**CALIFORNIA GEOLOGICAL SURVEY
FAULT EVALUATION REPORT FER 253
SUPPLEMENT NO. 1**

**THE HOLLYWOOD FAULT
in the Hollywood 7.5' Quadrangle
Los Angeles County, California**

The purpose of this supplement to the FER is to review and address these public comments forwarded by the SMGB, comment on additional reports sent to CGS after preparation of the FER, and to comment on field observations of fault trenches and other subsurface investigations by CGS after the public comment period. The location of the study area is indicated on Figure 1 and the reader is referred to FER 253 dated February 14, 2014 for other necessary background material (<ftp://206.170.189.144/pub/dmg/pubs/fer/253>).

PUBLIC COMMENTS, AND RESPONSE

Figure 11 – Cross-section from GDC Site 3 showing anticlinal folding of Pleistocene debris flow deposits, inferred stratigraphic form lines and faults that offset this unit. Numbered annotation at each fault reflects GDC’s observed stratigraphic separation at each location. Figure from GDC, 2014c.

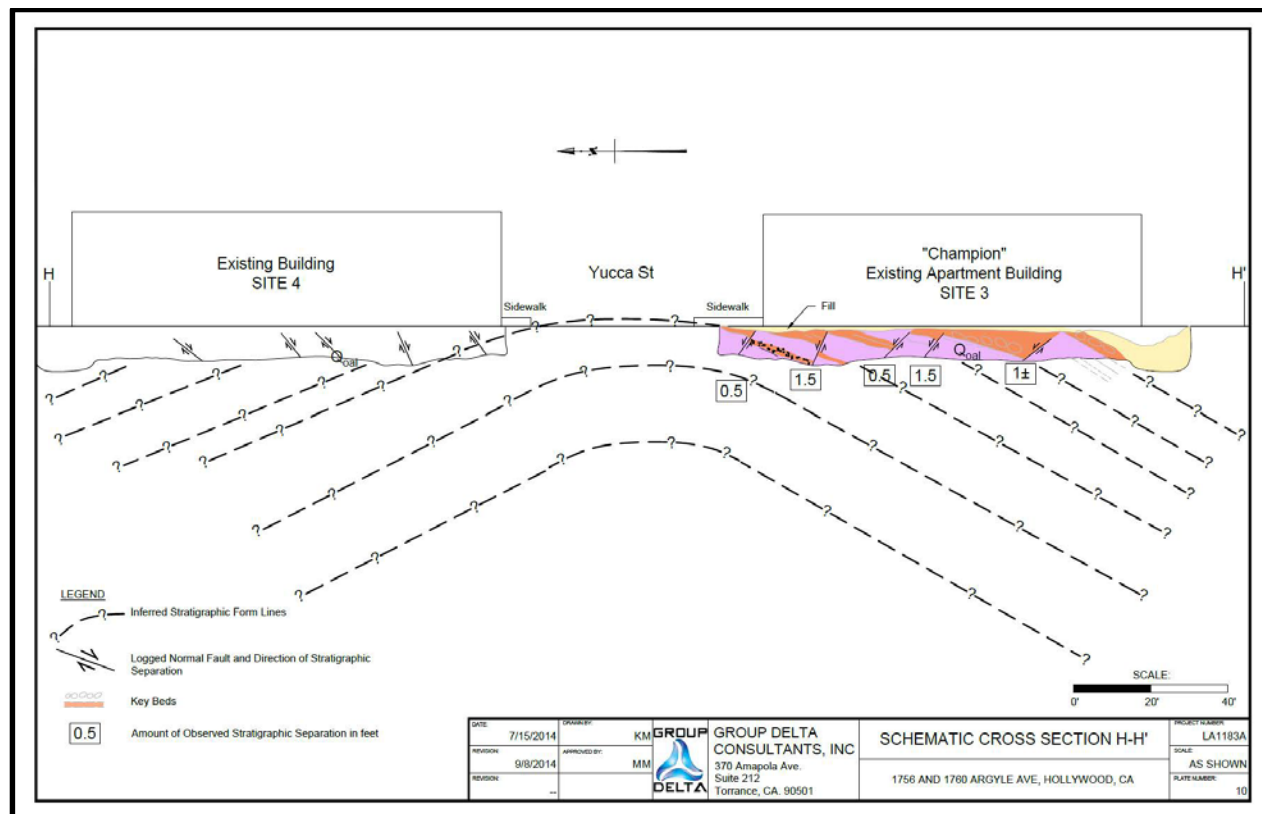
At locality S2-11, (GDC Site 3, Figure 8), Group Delta (2014c) reported the site is underlain by fill materials and older alluvial debris flows, which in turn are underlain by Modelo Formation. Their site investigation included both CPT and core borings, and an approximate 8-foot deep trench on the west side of the site. GDC reported the older alluvial unit consists of Pleistocene debris flows, and state that this unit is faulted. They associated this fault with a localized west-northwest oriented anticline, which extends north to GDC Site 4, as shown in their cross-section (Figure 11). They interpret these features to be due to regional transpression and not to seismogenic faults. They report the age of the faulting at this site is older than 35 ka based on unbroken mudflow deposits found to the west at Site 2.

The data presented in the GDC report is consistent with the interpretation that the deposits are of Pleistocene age although it is unclear why these “debris flow” deposits are differentiated from the similarly comprised and deformed older alluvial fan unit exposed and described at site 2.

Interpretation that the faults are local bending moment faults is not consistent with CGS field observations within the trench. CGS noted a significant lack of correlation across the southernmost fault, and that thickness of units changed across most of the faults, which indicates a component of lateral displacement (Figure 12). The southernmost fault appeared to be a prominent fault, as correlative units across the fault were not found, suggesting this fault trace may have seen the most displacement. No evidence for, or against, Holocene faulting was reported on this site because Holocene deposits, if present, were likely removed during site development.

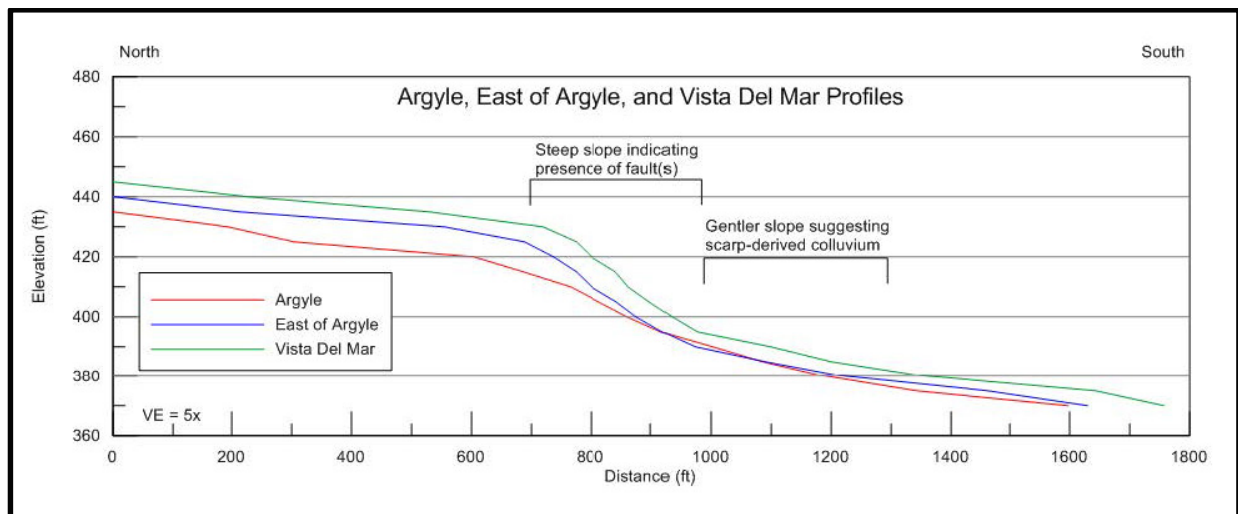
A comment was submitted by Lettis Consultants International, Inc. (LCI), accompanied by a transmittal letter by Elkins Kalt Weintraub Reuban Gartside, LLP on April 8, 2014 to the SMGB to specifically address the BLVD 6200 property located at 6201 Hollywood Boulevard in Hollywood (locality S2-12, Figure 7). In their report, they present data and analysis of the site and vicinity, with additional focus on the southern, discontinuous trace of the Hollywood Fault that is mapped on the Preliminary EFZ map to underlie the site. LCI presented detailed topographic profile analyses consisting of 3 sets of data including: review of historical 6-minute topographic maps, high-resolution lidar imagery, and high resolution ground survey topographic profiles along 8 closely-spaced, north-south oriented streets. These profiles were located within the streets adjacent to the BLVD 6200 site and along other nearby profile lines. They identified breaks in slope within the profiles of these transects, and included locations of scarps previously mapped by Dolan et al. (1997), the projection of fault traces mapped by CGS in FER 253, and the BLVD 6200 project boundary.

LCI stated that in addition to the prominent break in slope located immediately north of their site, a subtle break in slope is expressed across the southern portion of the site. They reported this southern slope break is located south of the southern discontinuous fault trace mapped by CGS. They suggest that subtle breaks in slope can be related to several factors: change in slope direction on the ground surface, or thickness and directional changes within the alluvial fan system. Their analysis noted that the subtle slope break is coincident with an east-west trending apparent scarp mapped by Hill et al. (1979), and a possible fault scarp mapped by Weber et al. (1980). In their review of the 1926 topographic maps, they indicated that Argyle Avenue did not yet exist at this location, and that possibly the subtle break in slope observed in the street may have been created during subsequent construction of Argyle. Alternatively, they concluded that this subtle break in slope reflected in the composite topographic profiles (Figure 13), is most likely related to scarp-derived colluvium from the steep break in slope to the north.

Based on an analysis of available boring log data from adjacent studies in the area, LCI interpreted an alternative location for both the northern trace and the southern trace that they suggest would best fit the previous mapping by Dolan et al. (1997).

The data presented in the LCI report was particularly helpful in CGS review of topographic breaks in slope. Fault traces mapped by CGS in this area were based on geomorphic interpretation using similar data as used by LCI, as well as fault traces from Dolan et al. (1997), Hill et al. (1979), and Weber et al. (1980). In addition, the southern discontinuous fault trace was mapped using original subsurface data from Geotechnologies, Inc. (2006) that included logs of borings and the site topographic base map. CGS review of the high resolution street survey data submitted by LCI in their report, and detailed observations included in the Geotechnologies (2013) report, finds justification to modify our interpretation of the location of the principal southern fault trace.

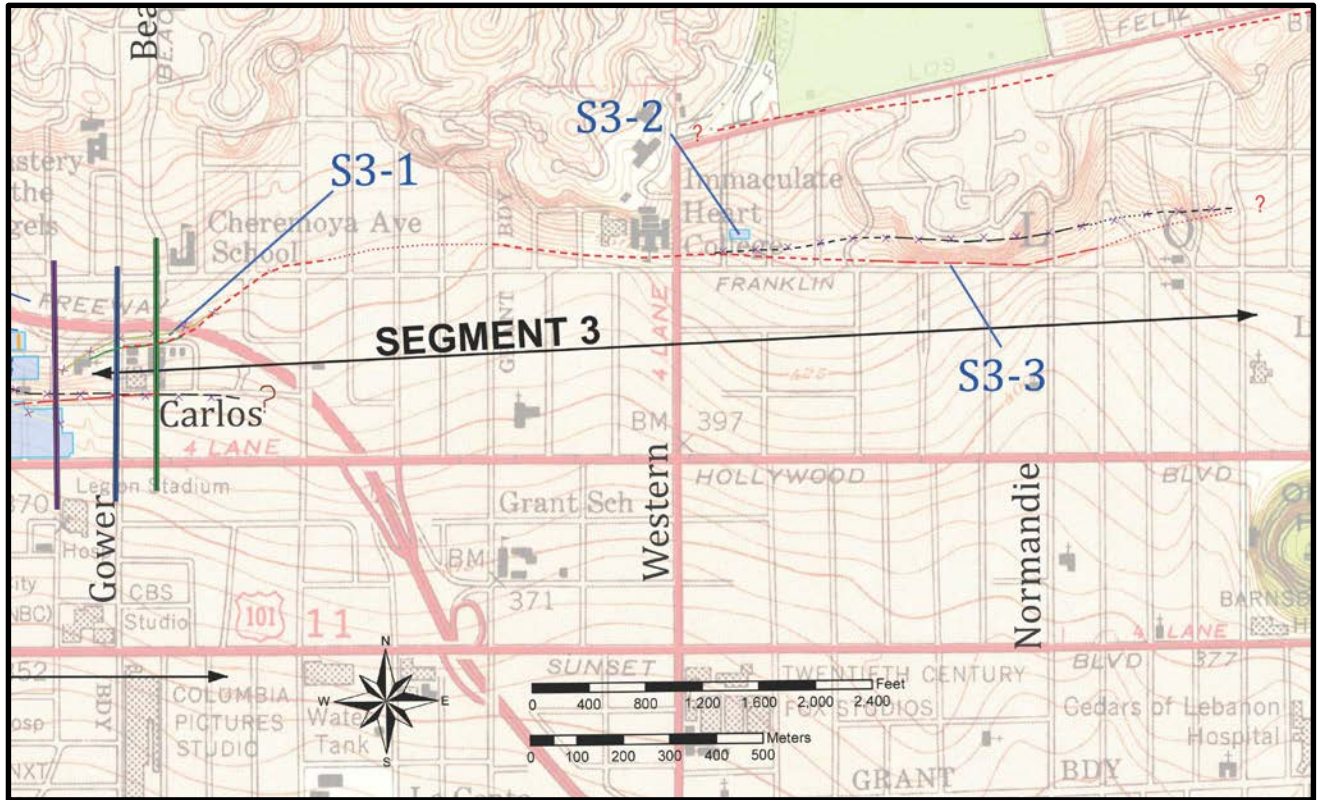
Bay City Geology, Inc. (2014) performed an investigation for a site located within the Preliminary EFZ at locality S3-2 (Figure 14). Three large diameter borings were drilled, revealing a thin layer of older alluvium, underlain by weathered Topanga Formation siltstone and sandstone, grading to less weathered bedrock at about 21 feet bgs. Bedding planes in Topanga measured in the borings had northwest strikes, with dips to the southwest. Bay City stated that similar geologic units were encountered in all of the borings at similar depths, where they indicated this was positive evidence for continuous, unfaulted geologic units across the site. From these data, they inferred the Hollywood fault is located south of the site.

At locality S3-3 (Figure 14), CGS revised the location of the Hollywood Fault trace along Franklin Avenue east of Western, based on a review of the 1926 topographic map covering this area. Our initial interpretation in this area utilized a later version of the topographic map, where topographic details were more subtle. Our reinterpretation of the fault trace follows closely with the trace mapped by Dolan et al, 1997.

The data presented in the Bay City Geology report is consistent with the interpretation presented in the initial FER that the Hollywood Fault lies south of this site as shown on the preliminary Alquist-Priolo Earthquake Fault Zone map.

As a result of this minor adjustment, the EFZ boundary has shifted slightly to the south.

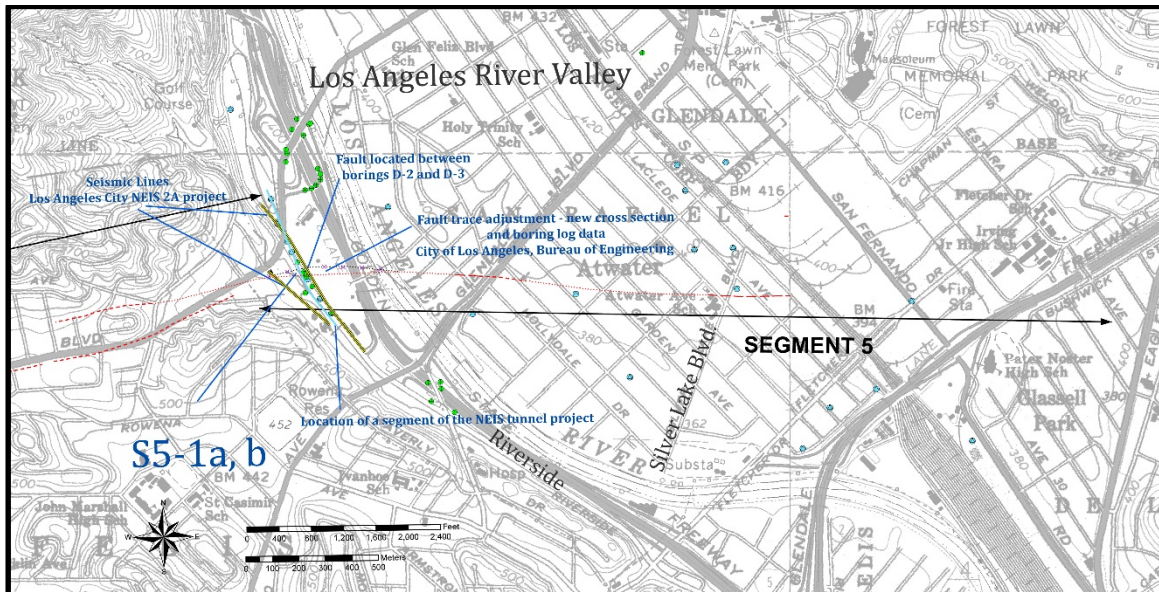
David L. Perry, comment letter dated April 18, 2014: Mr. Perry submitted a comment to the SMGB on April 18, 2014 regarding the location of the Hollywood Fault and analysis of the supporting data from the Northeast Interceptor Sewer (NEIS2A) project area (locality S5-1a) as shown on Figure 15. In this letter, Mr. Perry reports the cross-section utilized in the FER (from the Los Angeles Department of Public Works, 2013) is vertically exaggerated, and includes borings that were projected up to 63 feet horizontally into the section. In the AMEC (2013) report, he states there is a cross-section drawn at a 1:1 scale, and acknowledges subsequent boring data performed by the City of Los Angeles Department of Public Works (City of Los Angeles, 2013) was included in the cross section utilized by CGS for the FER. Mr. Perry's interpretation of the data, and his extensive experience in this area suggests the "thickening of young alluvial deposits within the fault zone" as reported by CGS, is likely attributed to paleochannels from the Los Angeles River system, and that the projection of the data into the cross-section should include consideration of geomorphology and paleochannel geometry.

Patrick Schmidt, and Fred Burnett, (2014): Mr. Schmidt and Mr. Burnett of the City of Los Angeles Bureau of Engineering (BOE) provided CGS a technical paper they prepared in February, 2014 that was submitted to the Underground Construction Association's North American Tunneling Conference (NAT). In this paper, they discussed some of the exploratory methods implemented during the Northeast Interceptor Sewer project (NEIS), including: borings with down-hole geophysics, packer and pressuremeter testing, CPT testing, Remi surveys and surface geophysics lines. They reported some of the difficult conditions they anticipate encountering during tunneling along the fault zone, including: squeezing and running ground conditions, high methane gas concentrations, and up to 5 bars of water pressure. They reported the main Hollywood Fault was located between exploratory borings M08-B4 and M08-B5, where interpolation of the geophysical surface survey data identified two north dipping fault planes with three south-dipping secondary faults in the hanging wall that merge at depth.

City of Los Angeles (2013) conducted an additional fault study that included 3 borings that were drilled during April - May 2013 for the NEIS 2A sewer project. These borings were drilled to further define the limits of the deep older alluvium associated with the active trace of the Hollywood Fault at locality S5-1b. The borings also helped to define the artesian groundwater pressures, depth of bedrock, and methane concentrations they will likely encounter during tunneling operations.

We reviewed Mr. Perry's comments, and appreciate the insight he provides in this area, and particularly with his experience on the NEIS project. Regarding projection of data into the NEIS profile, we acknowledge the thickness variation of recent alluvium in the vicinity of subsurface faulting may be due to erosion processes, and paleochannel morphology along the ancestral Los Angeles River system.

Our review of the updated cross section and boring logs received from the City of Los Angeles (locality S5-1b), finds that the original projected surface trace of the fault should be shifted to the south approximately 90 feet. We have revised the location of the fault trace based on this new cross section and supporting data. A corresponding revision of the zone boundary has been made.
